CASPER_sample_adj.dwg

Verification Date: April 8, 2014
 Verification Completed: 12:19:16 PM
 Number of Errors: 1
 Number of Warnings: 2
 Community: SOUTH FOOTHILLS;SECTION 23

OVERALL STATUS: Failed

CASPER
Calgary Automated Survey Plan Evaluation and Reporting
Plan Outline

Lot Lines (Layer 24/17)

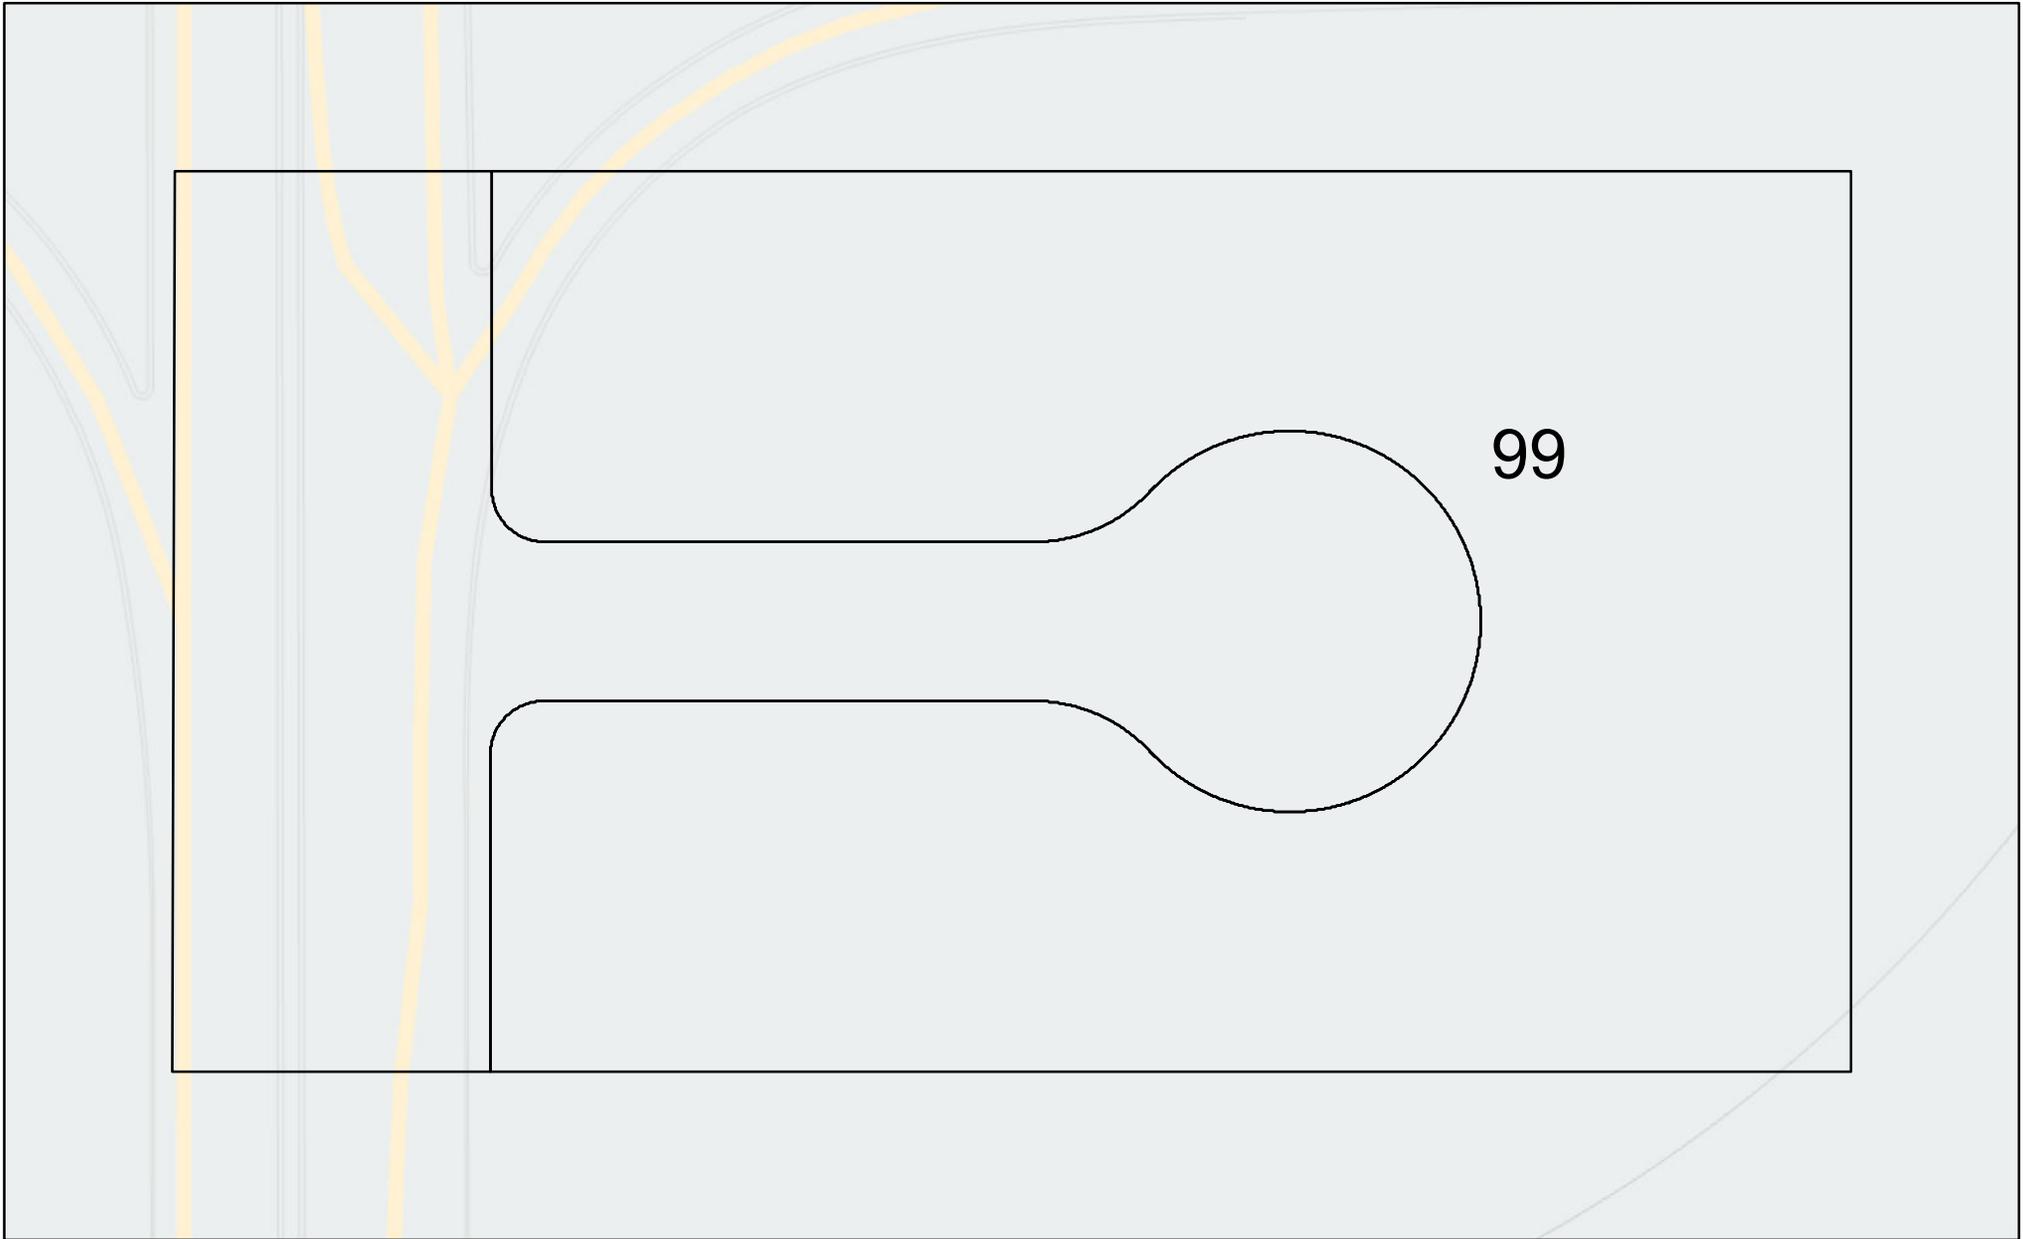
Failed

Lot/block line connectivity error detected on one or more lines. This must be corrected prior to final submission.
Note: this may be due to the existence of divider lines, and if so this message can be ignored.

Lot Numbers (Layer 19)

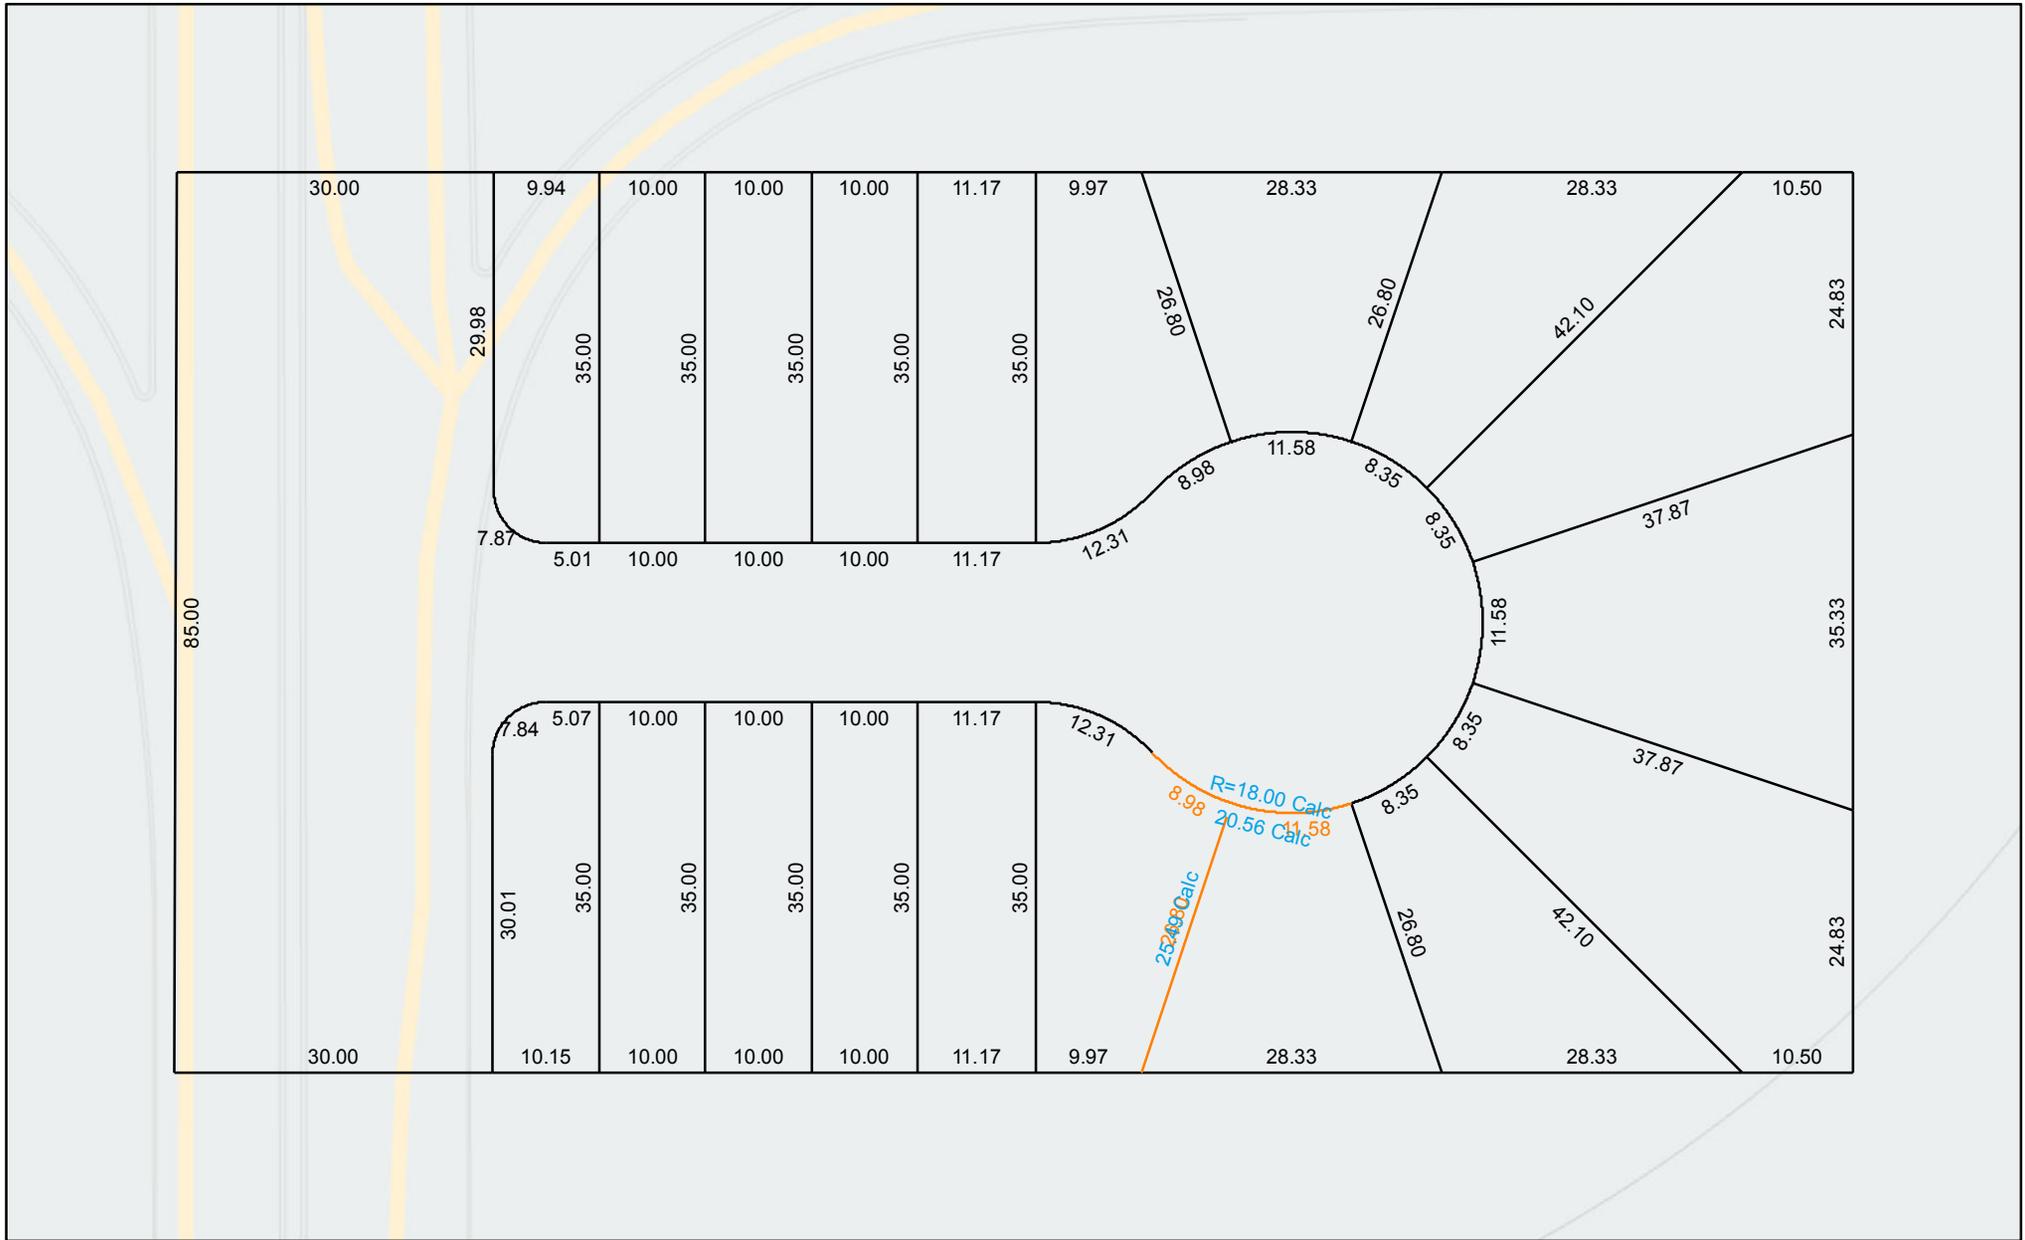
Warning

Lot numbers are not available for one or more lots, or multiple lot numbers exist for one or more lots. Note that this may be the result of lot line connectivity errors - check if there are any errors in the Lot Lines Report first. This should be corrected prior to final submission.
